**BEFORE THE INDEPENDENT HEARING PANEL
FOR THE QUEENSTOWN LAKES PROPOSED DISTRICT PLAN**

In the matter of the Urban Intensification Variation to the proposed
Queenstown Lakes District Plan

**SECTION 42A REPORT OF RACHEL GRACE MORGAN
ON BEHALF OF QUEENSTOWN LAKES DISTRICT COUNCIL**

REZONING REQUESTS FOR THE RESIDENTIAL ZONES

Figure 15: Notified UIV zoning and general location of submissions in support and opposition.

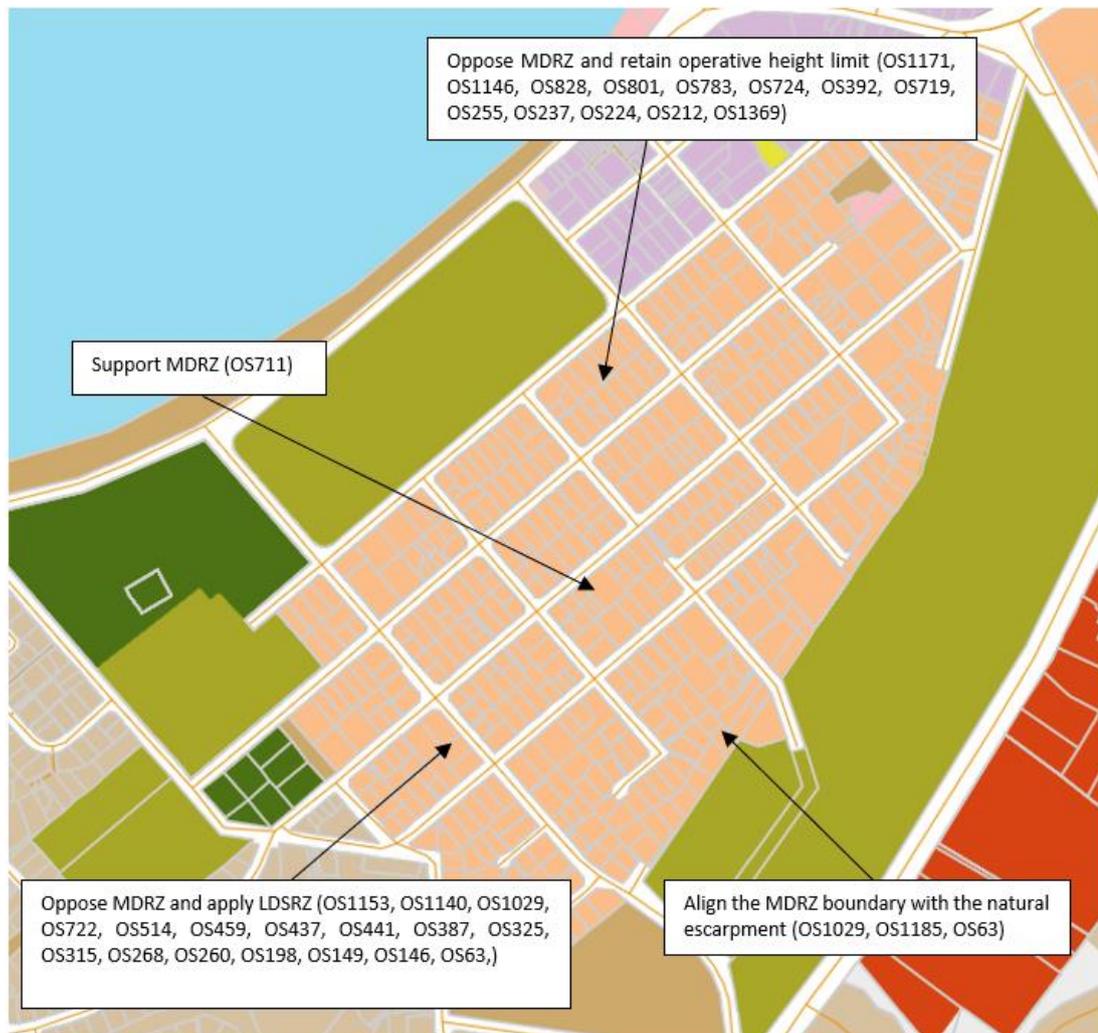
13.2 Forty submission points and two further submission points have been received regarding the zoning of this area. The relief sought by the submitters is shown spatially on the plan at Figure 15. The key issues raised in submissions, which seek changes to the notified UIV are summarised as follows:

13.3 I support applying the MDRZ as per the notified UIV to Area 7 as shown in Figure 15 above. I do not agree with submitters that seek to retain the existing PDP zoning, apply a lower density zone or otherwise reduce heights and densities within zone rules.

raised by submitters in relation to views, sunlight access and the appearance of higher density development will be addressed by the proposed development standards including building coverage, yards, building length, recession planes which seek to provide appropriate levels of on-site amenity (including sunshine).⁷⁴ I agree with this statement for the reasons I have provided earlier in this evidence.

- 13.9** The management of groundwater and effects of development on the Wānaka Basin Cardrona Gravel Aquifer is a matter for the Otago Regional Council (**ORC**) to regulate through its Regional Plan. ORC has not made a submission on the UIV raising concerns with development in Wānaka. I have no technical evidence on the potential cumulative effects of development on the Wānaka Basin Cardrona Gravels Aquifer and I would consider any evidence on this matter put forward by the submitter. However, in my experience, a high groundwater table is not unusual in an urban area, and effects can typically be managed with appropriate engineering design. Although I acknowledge that it does increase the cost of development and would have an impact on overall feasibility.

- 13.10** In a similar vein, submitter 1153 has raised concerns about the potential impact of higher density development on Bullock Creek. On this, I note that the surrounding catchment is already zoned for urban residential development with minimum requirements for permeable surfaces applying and which are not changing under the notified UIV. In my opinion, the change in zoning and the effects on Bullock Creek are sufficiently addressed by the rules in the UIV and the Regional Plan, with respect to stormwater quantity and quality.

Figure 17: Notified UIV zoning and general location of submissions in support and opposition.

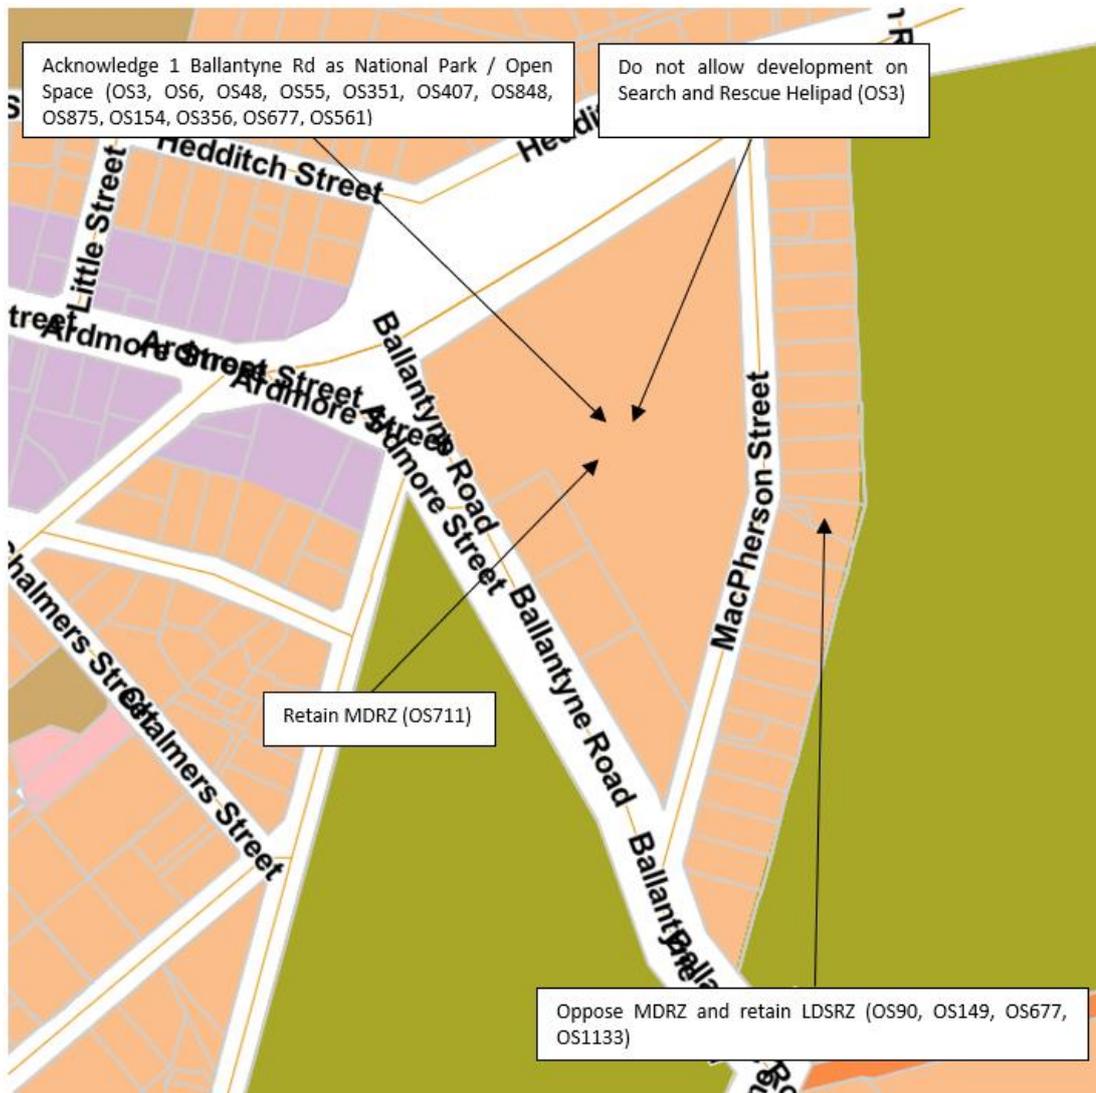
spatially on the plan at Figure 17. The key issues raised in submissions, are summarised as follows:

- 14.7** Submitters oppose the MDRZ applying to McPherson Street on the grounds that the area has an open landscaped character, is an established residential area and would be adversely affected by loss of sunlight and privacy as a result of the amended zoning. In my opinion, the proximity of the site to the open space to the west and east makes the block especially suitable for medium density development, being able to leverage the outlook, amenity and views that those spaces offer. While there would be a change to the existing environment if redevelopment occurs in line with the MDRZ, as I have explained above, I do not consider this to necessarily be an adverse effect, and the MDRZ provisions themselves and consenting processes are framed to ensure that quality urban design solutions are achieved (Objective 8.2.2). While McPherson Street does have some elevation, the sites are all within good walking distance of the Wanaka Town Centre and have a good level of accessibility as assessed by Mr Wallace. On this basis, medium density development in this location would in my opinion make a positive contribution of housing opportunities (Objective 3.2.2.1(f)) which is particularly important against a backdrop of high residential demand as outlined by Ms Fairgray.

- 14.8** Retain the notified UV zoning for the sites on the eastern side of McPherson Street.
- 14.9** Amend the notified UV zoning for the sites on the western side of McPherson Street to retain the PDP zoning, being the LDSRZ.
- 14.10** For the recommended changes to the west of McPherson Street I make the following comments with respect to Section 32AA matters, which summarise the analysis already undertaken:
- (a) The recommended amendments to the zoning will more efficiently and effectively achieve the relevant objectives of the PDP, particularly Objective 3.2.2.1 which seeks to provide a high quality network of open spaces and community facilities. The LDSRZ better aligns with the recreational and social activities that the intended for this block;

Figure 19 & 20: Notified UIV zoning and general location of submissions in support and opposition and alternative relief sought in OS956.

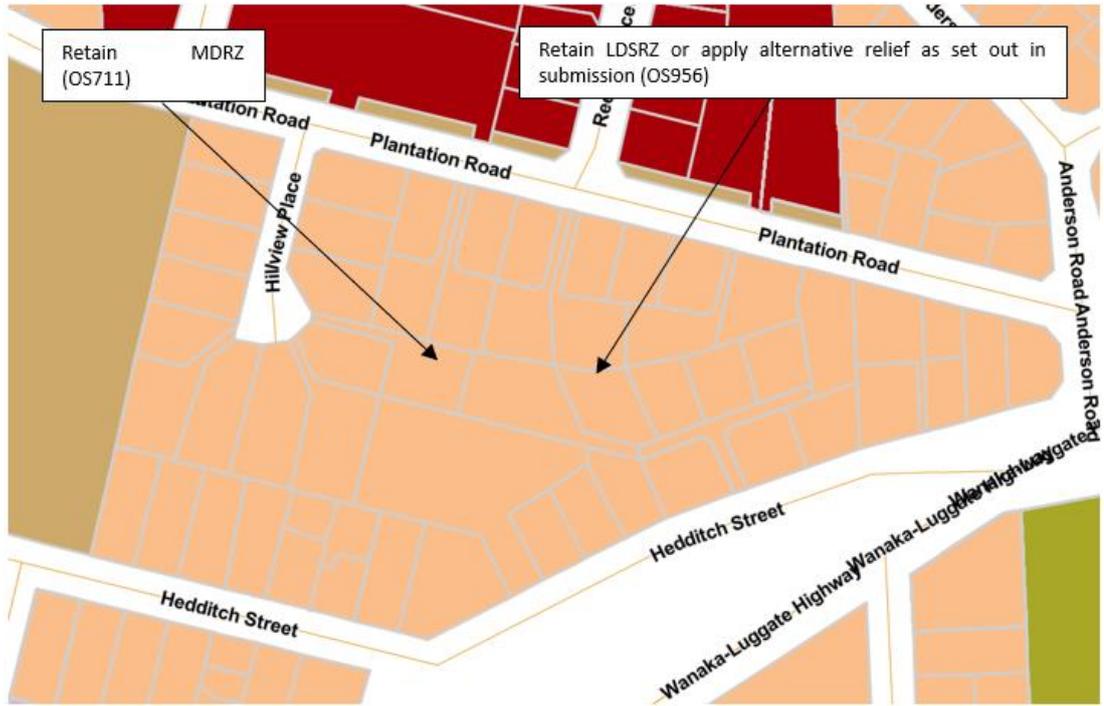
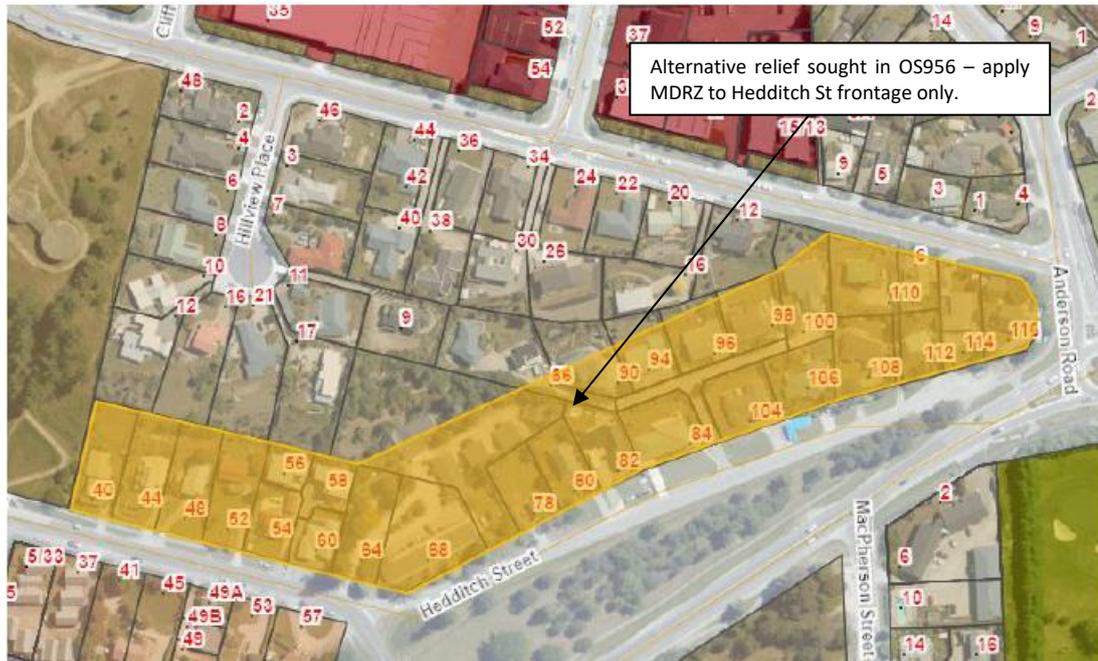
15.2 Two submissions and one further submissions have been received regarding the proposed zoning of this area. The relief sought by the submitters is shown spatially on the plan at Figure 19. The key issues raised in submissions are summarised as follows:

- (a) Oppose the application of the MDRZ on the basis that the area has not been demonstrated as high accessibility and relative demand for the MDRZ in the area.⁸¹ The submitter is seeking to retain the LDSRZ within this area or as an alternative narrow the proposed rezoning so that MDRZ is only retained in the area accessed by Hedditch Street as set out in Figure 20; and
- (b) Support the proposed upzoning to MDRZ within this area.⁸²

- (c) If the development potential enabled by the MDRZ is taken up, this would result in a change in amenity values from the existing environment, including visual amenity, privacy and sunlight. However, consistent with the objectives and policies of the MDRZ, development is intended to provide for high quality living environments with reasonable maintenance of amenity values for adjoining residents (PDP Objective 8.2.3) and this is achieved through the rules and requirements for resource consent; and

Figure 22: Notified UIV zoning and general location of submissions in support and opposition.

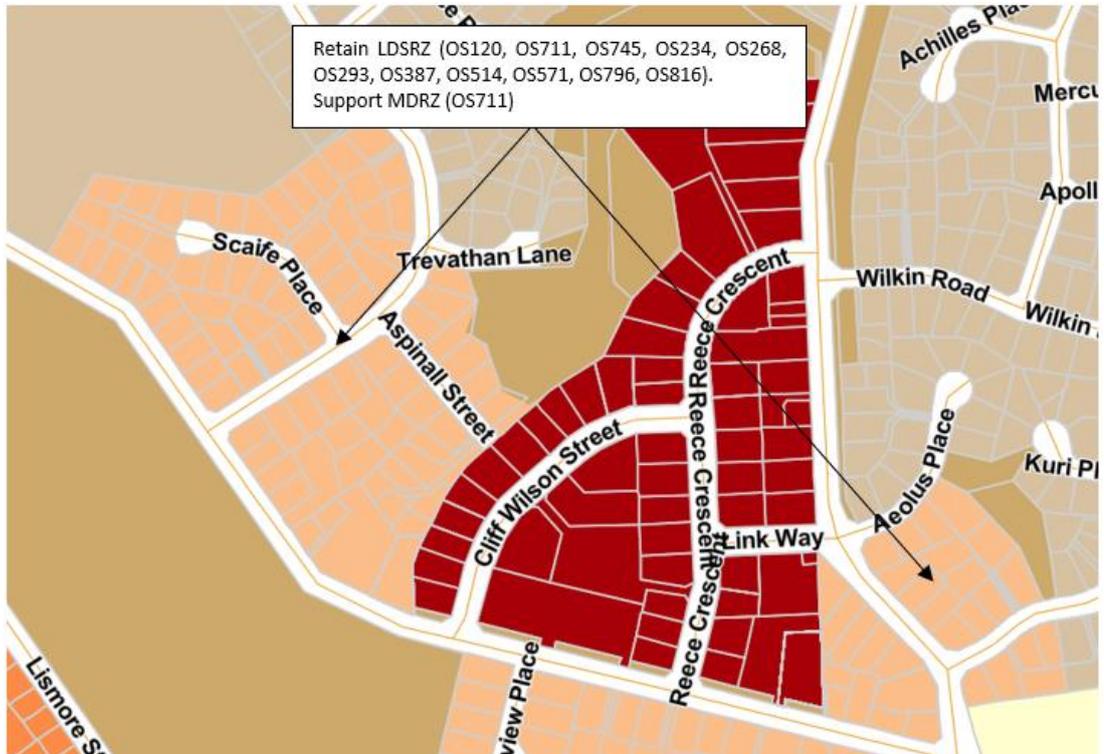
16.2 Twelve submission points and six further submission points have been received regarding the zoning of this area. The relief sought by the submitters is shown spatially on the plan at Figure 22. The key issues raised in submissions, are summarised as follows:

- (c) If the development potential enabled by the MDRZ is taken up, this would result in a change in amenity values from the existing environment, including visual amenity, privacy and sunlight. However, consistent with the objectives and policies of the MDRZ, development is intended to provide for high quality living environments with reasonable maintenance of amenity values for adjoining residents (PDP Objective 8.2.3) and this is achieved through the rules and requirements for resource consent; and
- (d) Relying on the evidence of Mr Powell, development can be effectively integrated with existing and proposed infrastructure over time (Policy 3.2.2.1).

Figure 24: Notified UIV zoning and general location of submissions in support and opposition.

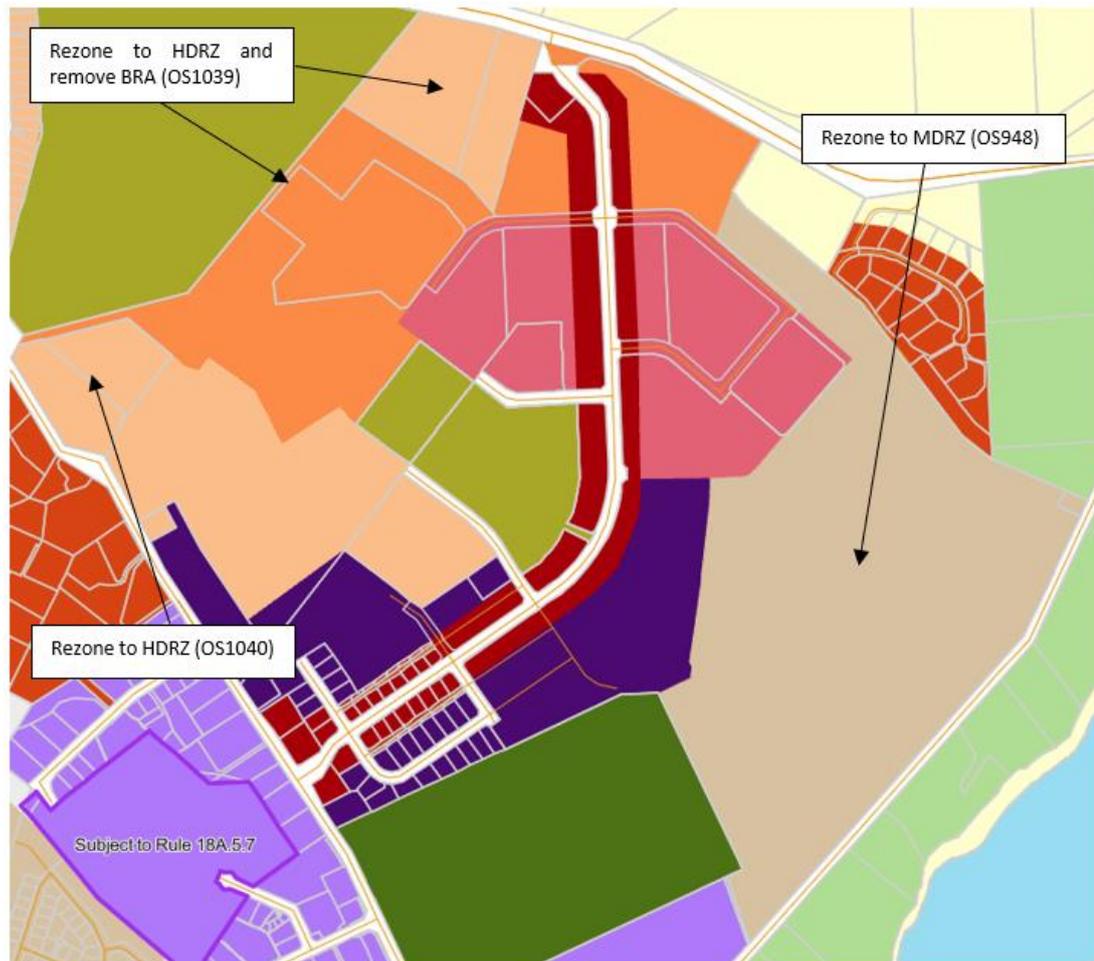
- (a) Rezone all the LDSRZ areas within Three Parks to MDRZ,⁸⁵
- (b) Remove the Building Restriction Areas,⁸⁶ and
- (c) Upzone various properties to HDRZ.⁸⁷

17.12 Submitters 1039 and 1040 seek to remove the entire Building Restriction Area from the western extent of Three Parks where it adjoins the Wānaka Golf Course. They state that this would enable the site and surrounds to be developed to a greater intensity than otherwise would be provided for, in line with the national direction sought and subsequent urban intensification variation put forward by QLDC. The submitters refer to the recommendations of the IHP for the Stage 3 PDP Hearings, which states the following:

17.10 Regarding the area to the east of Sir Tim Watts Drive, Mr Wallace supports some rezoning of the land within 400m of some or all of the main amenities within Three Parks (being schools, supermarket, open space and employment). Mr Wallace's recommended rezoning extent is shown in Figure 6 of his EiC and provides for two block of 55m in depth and streets. Ms Fairgray's comments on relative demand for residential use are relevant to this area, as are her comments on the overall increase in residential demand for Wānaka arising from the Council's latest population projections (March, 2025). This weighs in favour of providing more opportunities for residential intensification in Wānaka and this greenfield land is an appropriate and efficient location to do so in my opinion. The large scale, greenfield nature of the land to the east of Sir Tim Watts Drive means that

17.11 On the basis of the evidence currently available, I support partial rezoning of the land to the east of Sir Tim Watts Drive to MDRZ, however, I would benefit from technical evidence from the submitter on this matter. This would usefully address interface conditions, and whether any amendments to the indicative roading and open space network shown in the Three Parks Structure Plan are necessary.

- 17.15** Rezone 27 Ballantyne Road and 100 and 124 Wānaka-Luggate Highway HDRZ.
- 17.16** Rezone part of the LDSRZ on the eastern side of Sir Tim Watts Drive to MDRZ, noting that my position on this may be refined in response to submitter evidence.

- 17.17** Retain the Building Restriction Areas on the western side of the Three Parks Structure Plan area, noting that my position on this may be refined in response to submitter evidence.

Figure 25: PDP zoning in this area and general location of submissions in support and opposition.

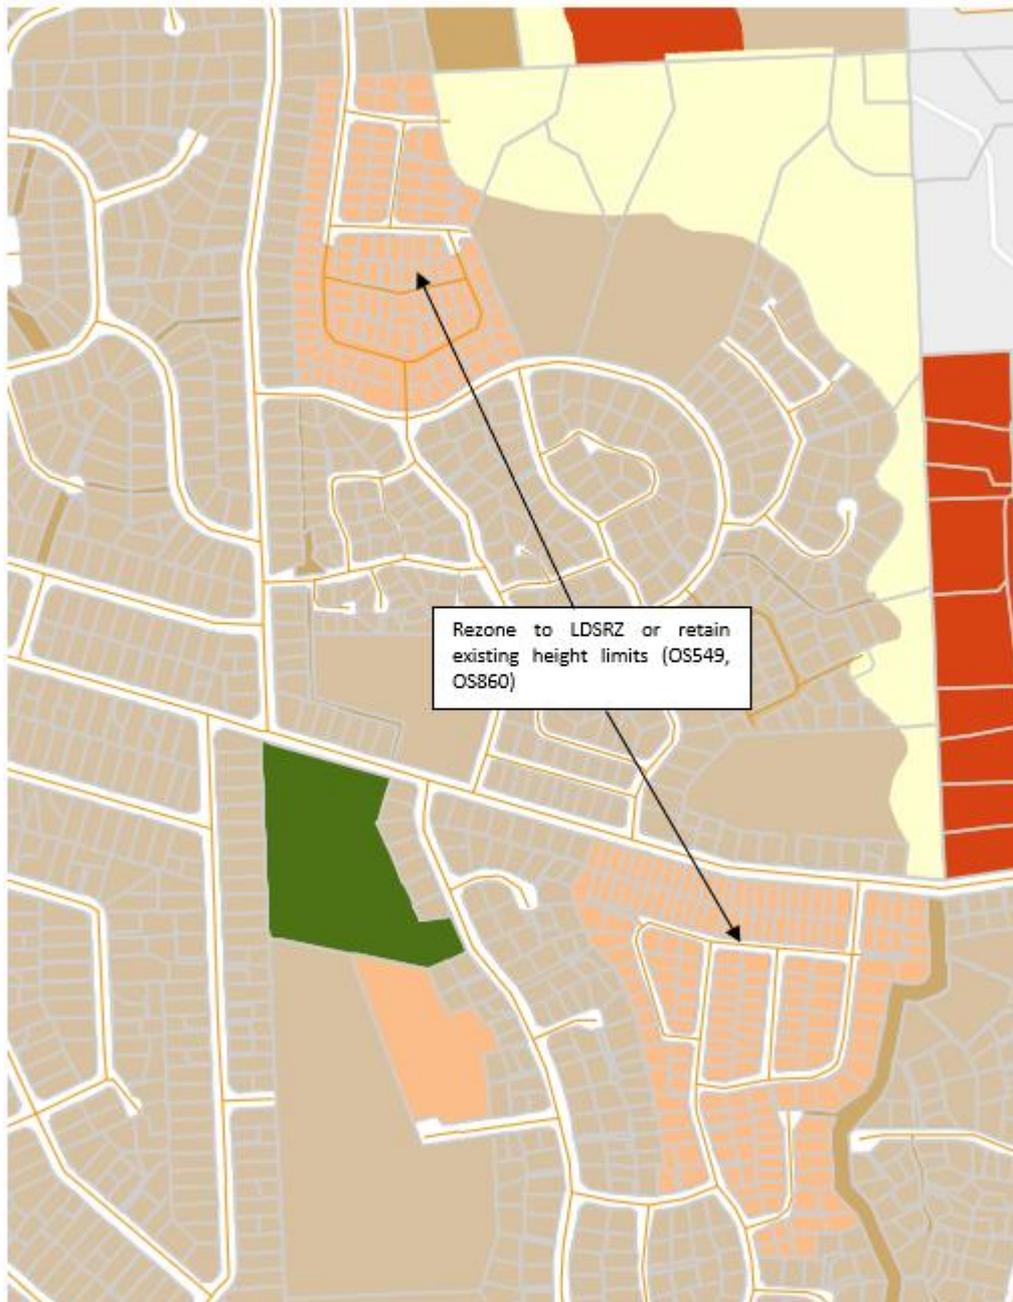
- 18.1** Area 12 includes the MDRZ in The Heights and Clearview. Under the PDP the zoning of this area is MDRZ as shown on Figure 25. The notified UIV sought to retain the MDRZ within this area.
- 18.2** Two submissions⁹³ have been received seeking that the Heights and Clearview are rezoned to LDSRZ. This is on the basis that these areas are not accessible at all. While the submitters are comfortable with the existing MDRZ, they have concerns with the 12m height limit if this zoning is retained within these areas.
